FINAL ENVIRONMENTAL IMPACT STATEMENT

**THE VILLA AT GLEN COVE
PROPOSED RESIDENTIAL CONDOMINIUM DEVELOPMENT
EAST SIDE OF GLEN COVE AVENUE AT CRAFT AND YOUNG AVENUES
CITY OF GLEN COVE, NASSAU COUNTY, NEW YORK**

This document is a Final Environmental Impact Statement for the Application of Livingston Development Corp. for Site Plan Approval, Incentive Density Bonuses and Waivers of Inclusionary Housing and Hillside Protection for The Villa at Glen Cove Residential Condominium Development.

Figure 2
Drawing Number

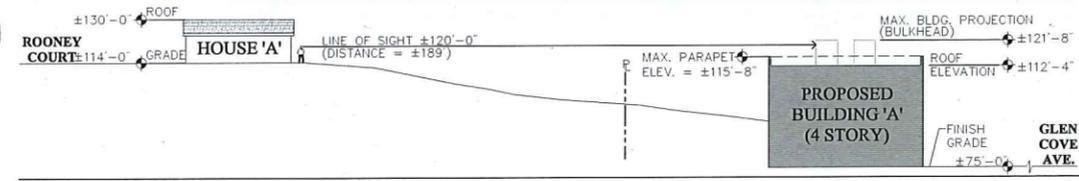
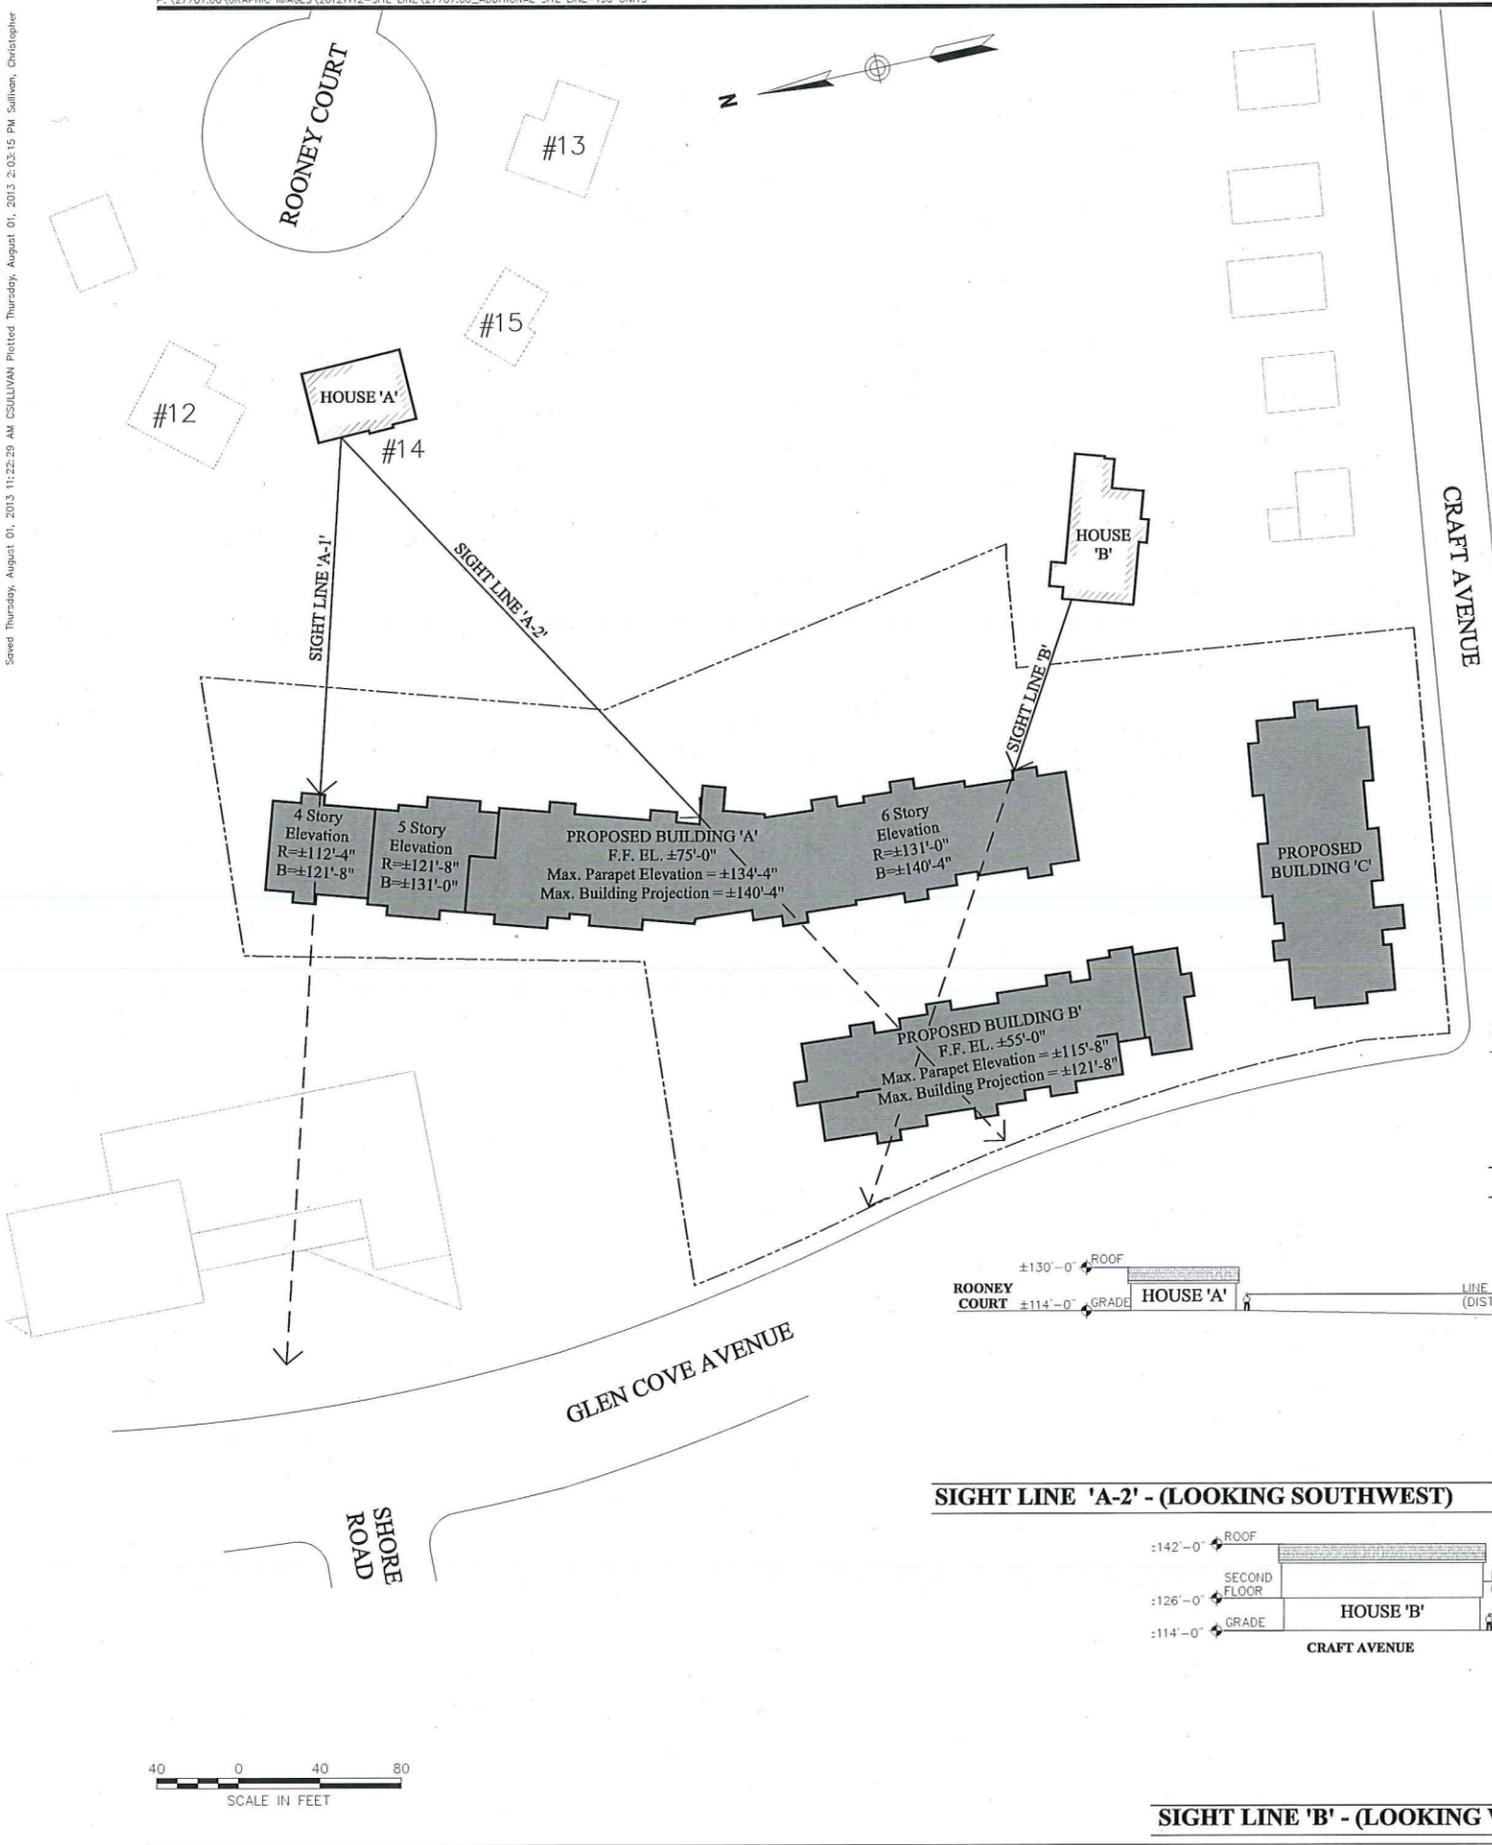
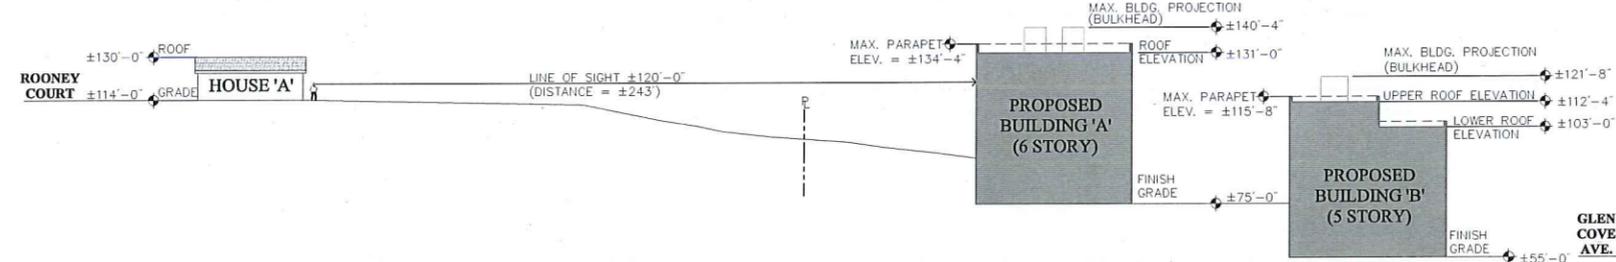
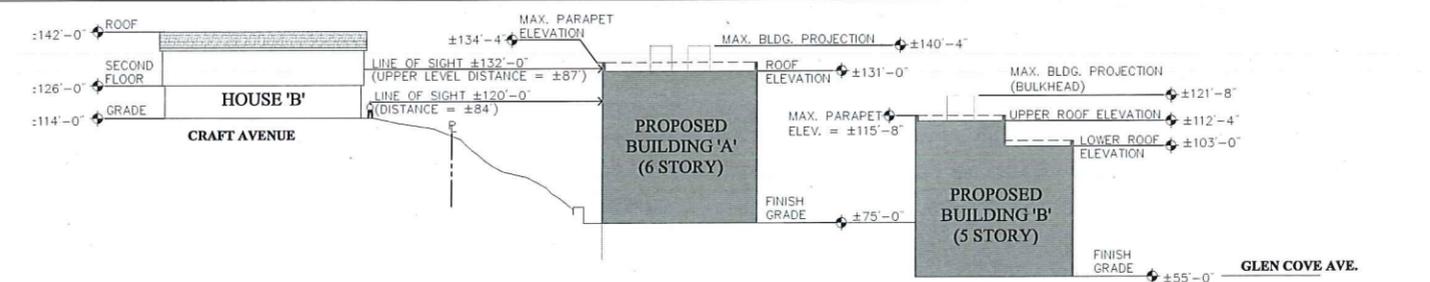
As can be seen in these line-of-sight diagrams (Figure 1 and Figure 2), while the 196-unit plan (which removes one story from Building A and staggers the height of the roof along Building A, when compared to the 216-unit plan) reduces the visual impact to the closest neighbors from those of the 216-unit plan, the 196-unit plan still creates significant visual impacts, as the neighbors to the east will be looking directly at the large mass at the rear façade of proposed Building A.

With respect to the 196-unit plan, as shown on Figure 2, the A-1 drawing indicates that along this line-of-sight, the viewer, who is standing approximately 172 feet from the rear façade of Building A and 189± feet from the nearest bulkhead, would be looking at the stair bulkheads for the rooftop units, which would extend almost two feet above the viewer's line-of-sight at that point on the roof of this four-story portion of the building. As noted in Section 1.2.2, the stair bulkheads are much larger than typical building projections such as single emission air stacks or conventional mechanical equipment for apartment buildings.

As can be seen from the A-2 line-of-sight drawing in Figure 2, since Building A in the 196-unit plan is six stories along this line-of-sight, the viewer, who is standing approximately 243 feet from the rear façade of Building A and 260± feet from the nearest bulkhead, would be looking directly at the bottom of the sixth (top) floor of the building (with one residential story above). The top of the parapet would be over 14 feet above the viewer and the top of the stair bulkhead would be over 20 feet above the viewer at this point. As noted above these bulkheads are much larger than typical building projections.

With respect to Sight Line B for the 196-unit plan (see Figure 2), this line-of-sight drawing shows that, at ground level, the viewer in this location (who is standing approximately 84 feet from the rear façade of the building) is looking directly at the back of Building A at near the top of the fifth floor of the building at that point (with one residential story above). The top of the parapet is over 14 feet above the viewer at ground level and the top of the highest bulkhead is just over 20 feet above the viewer. A viewer at the upper story, at approximately 87 feet from the building, would be looking at a point between the top of the roof and a top of the parapet, with the top of the large stair bulkhead extending approximately eight feet above that point.

Figure 6 – Warrant 2, Four-Hour Vehicular Volume

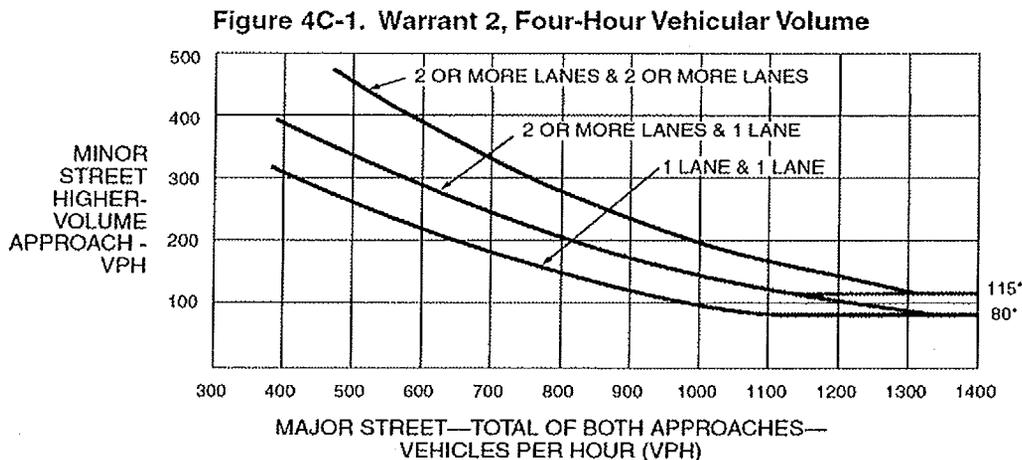
The calculation for Warrant 2 and for Warrant 3 Condition B should be expanded to better reflect the MUTCD required volumes. The required volumes are not static, but are plotted lines representing combinations of major and minor approach volumes; the projected volume plotted points should fall above these plotted lines to meet the warrants. The document should simply show the Figures 4C-1 and 4C-2 and show that the projected Build volumes fall short.

Warrant #2 (Four-Hour Vehicular warrant) and Condition "B" of Warrant #3 (Peak Hour warrant) use the warrant threshold curves shown in Figures 4C-1 and 4C-3, respectively, of the 2009 MUTCD. As requested, the corresponding major street and minor street traffic volumes at both of the intersections examined as part of the warrant analysis have been plotted on Figures 4C-1 and Figures 4C-3, as shown below in Figure 7 through Figure 10.
